**SUBDIVISION,
PLANNED UNIT DEVELOPMENT, &
SIDEWALK WAIVER STAFF REPORT****Date: June 19, 2014**

<u>NAME</u>	Tucker Place Subdivision
<u>SUBDIVISION NAME</u>	Tucker Place Subdivision
<u>LOCATION</u>	117 Batre Lane (Northwest corner of Batre Lane and Gaillard Street)
<u>CITY COUNCIL DISTRICT</u>	District 7
<u>CURRENT ZONING</u>	R-1, Single-Family Residential
<u>AREA OF PROPERTY</u>	8 Lots / 3.1± Acres
<u>CONTEMPLATED USE</u>	Subdivision Approval to create eight legal lots of record from an existing metes-and bounds parcel, Planned Unit Development approval to allow reduced front and side yard setbacks in a proposed Subdivision, and Sidewalk Waiver to waive construction of a sidewalk along Batre Lane and Gaillard Street.
<u>TIME SCHEDULE FOR DEVELOPMENT</u>	Immediate.

DETAIL SITE PLAN

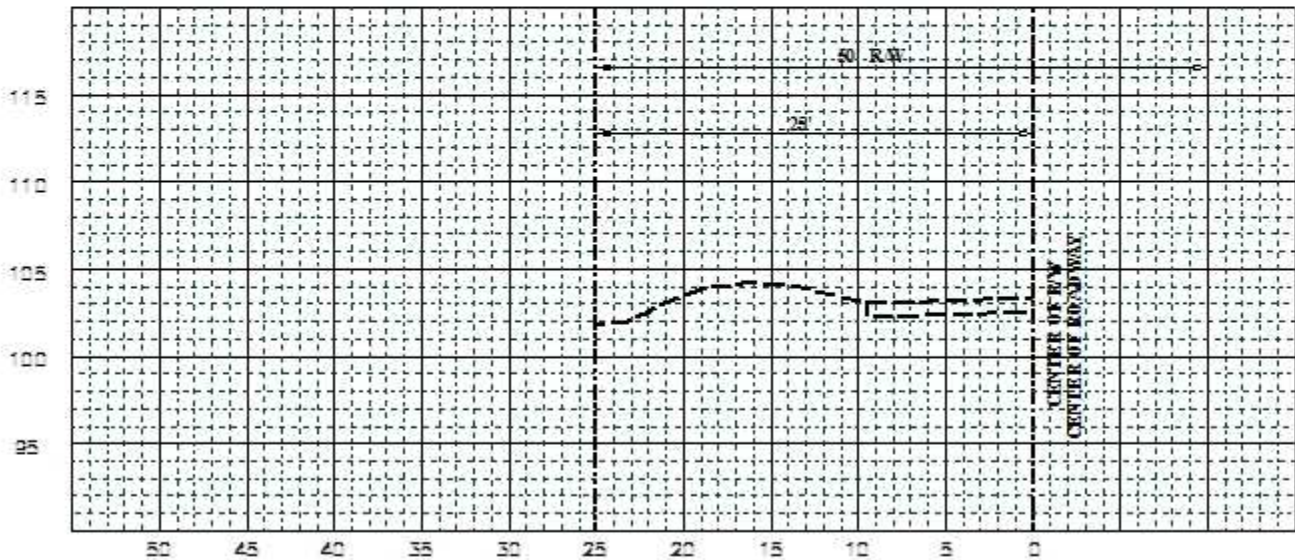
The site fronts Batre Lane along the East side, Gaillard Street along the South side, and an unopened alley along the West side. Batre Lane and Gaillard Street are minor streets without curb and gutter and requiring 60' rights-of-way. The plat indicates a proposed dedication to provide 25' from the centerlines of both streets in areas where the current rights-of-way are less than 50'. However, as dedication to provide 30' from the centerlines of Batre Lane and Gaillard Street was specified at a pre-development meeting, the plat should be revised to indicate such. Dedication of a 25' corner radius at the corner of Batre Lane and Gaillard Street should be required, as shown on the plat, adjusted to match the required 30' dedications. Gaillard Street is a closed-end street approximately 450' long. There is currently no compliant Fire apparatus access on Gaillard Street. However, the stated intent of the "pole" for Lot 7 is to allow for a hammerhead. Therefore, the plat should be revised to provide for a hammerhead, in compliance with Appendix D of the 2009 International Fire Code, to be coordinated with the Fire Department. Dedication should be required for such and construction completed prior to signing the Final Plat. In addition, if the current pavement width along Gaillard Street is less than 20', Gaillard Street should be paved to a minimum width of 20' to allow for such hammerhead prior to signing the Final Plat.

The plat illustrates a 20' front minimum building setback line along both street frontages for all lots except a 15' setback along Batre Lane for Lot 1, and a 15' setback for Lot 7. As the subdivision is of innovative design, the reduced front yard setbacks would be allowed via the PUD with a waiver of the 25' front setback requirement of Section V.D.9. of the Subdivision Regulations. The plat should be revised to illustrate the front building setback lines as measured from any required dedication. The PUD would also allow for the reduced side yard setbacks. The 8' rear yard setbacks along Lots 1 through 4 and Lot 8 are measured from the edge of the 25' ingress/egress easement across those lots and not from the rear property lines. The plat should be revised to indicate a rear setback as measured from the rear property line of 20.5' (8' from the edge of the easement plus 12.5' from the edge of the easement to the centerline of the easement/rear property line). The Final Plat should retain all approved setbacks.

Lot 7 would be a flag lot which is generally prohibited by Section V.D.1. of the Subdivision Regulations. However, as previously stated, the “pole” of this lot is intended to serve as a portion of the required hammerhead for Fire apparatus access. Due to the location of the existing structures proposed to remain, the shape of Lot 7 could be considered appropriate for the area in relation to the other proposed lots. Therefore, a waiver of Section V.D.1. would seem in order.

The plat indicates various drainage, utility and ingress and egress easements across the site. Therefore, a note should be required on the Final Plat stating that no structures are to be constructed within any easements. As there are two easements for ingress and egress on the site, a note should be placed on the Final Plat stating that the maintenance of the ingress and egress easements is the responsibility of the property owners. As this is not a private street subdivision, a note should be placed on the Final Plat stating that the ingress and egress easements are not to be gated or blocked in any manner so as to indicate a private street subdivision. A note should also be required on the Final Plat stating that the maintenance of the Detention/Common Area is the responsibility of the property owners.

- 9) revision of the plat to illustrate the front building setback lines as measured from any required dedications;
- 10) revision of the plat to indicate a 20.5' rear setback line for Lots 1 through 4 and Lot 8 within the ingress/egress easement;

- 1) revision of the site plan to indicate any required dedications of the Subdivision;
- 2) revision of the site plan to indicate a hammerhead for Fire apparatus access coinciding with the "pole" for Lot 7, in compliance with Appendix D of the 2009 International Fire Code, to be coordinated with the Fire Department;

- 7) revision of the site plan to illustrate the front building setback lines as measured from any required dedications;
- 8) revision of the site plan to indicate a 20.5' rear setback line for Lots 1 through 4 and Lot 8 within the ingress/egress easement;

DETAIL SITE PLAN

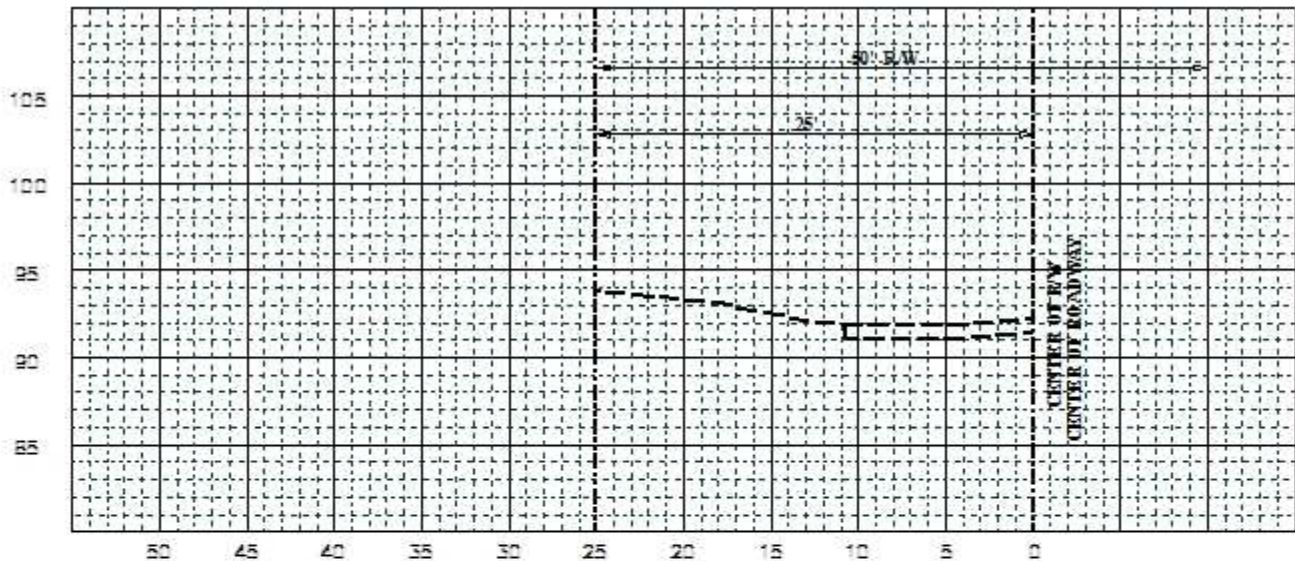
Batre Lane: It appears that there is sufficient room within the ROW, or within the property, for the construction of a sidewalk that could be permitted through the ROW Permit process.

Galliard Street: It appears that there is sufficient room within the ROW, or within the property, for the construction of a sidewalk that could be permitted through the ROW Permit process.

Installation of a sidewalk will have a negative impact on the existing tree roots along Gaillard Street and Batre Lane.

With regard to the Sidewalk Waiver request, the applicant states that there are extreme slopes on the site and that a sidewalk Waiver would be appropriate based on the constructability of a sidewalk in this area. It is further pointed out that there are no sidewalks in the vicinity. It is also stated that the narrow right-of-way conditions in this area do not allow for sidewalks to be built and that a sidewalk in this area would provide limited, if any foot traffic because it would be a sidewalk to nowhere.

A review of the site plan by City Engineering has determined that along both streets it appears that there is sufficient room within the right-of-way, or within the property, for the construction of a sidewalk. However, Urban Forestry has determined that the construction of a sidewalk along either street would have a negative impact upon the existing tree roots. In light of the fact that there are no other sidewalks within the immediate area, and in the interest of protecting the existing trees along the street frontages, staff is of the opinion that the Sidewalk Waiver should be approved, but only upon condition that the existing trees within the sidewalk area remain; if the trees are cleared, the sidewalks must be constructed.

Sidewalk Waiver: Based upon the preceding, the Sidewalk Wavier is recommended for approval, subject to the trees within the sidewalk area remaining: if the trees are removed, the sidewalks must be built.
